**Subject: California Clean Cars Proposed Regulations**

**Attachment A:**  
**ICCT Comments on the Proposed Amendments to the California Zero Emission Vehicle  
Program Regulations and Related Passenger Vehicle GHG Accounting**

## **Attachment B: ICCT Detailed Comments on LEV III Criteria Pollutant Requirements**

Figure A-2: ZEV and TZEV Targets Under Staff Proposal, Alternative A, and Current Regulation

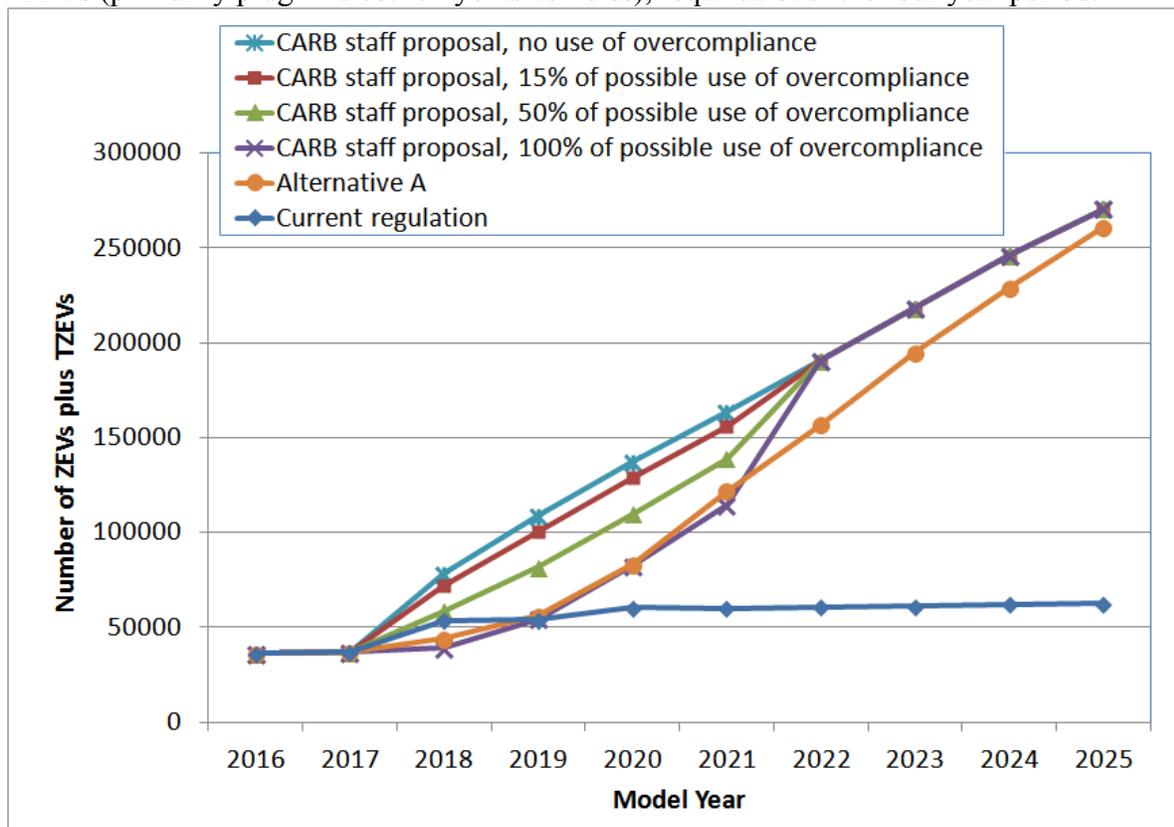
With the exception of the 100 percent use scenario, the ZEV deployment ranges in the “overcompliance” scenarios shown in Figure A-2 fall within a reasonable deployment ramp-up based on the evaluation in ICCT’s “Passenger Vehicle Electrification Task 1 Report: Technology Status”. In the 50% overcompliance scenario, a significant jump would be required between 2021 and 2022. If all manufacturers opt for the “overcompliance” option it would undercut CARB’s long-term targets, resulting in deployment rates from 2018-2021 similar to the “Alternative A” rejected by CARB staff. Therefore, we recommend that CARB establish a cap on participation in the overcompliance option that is within the range considered likely by CARB staff and no more than 50%.
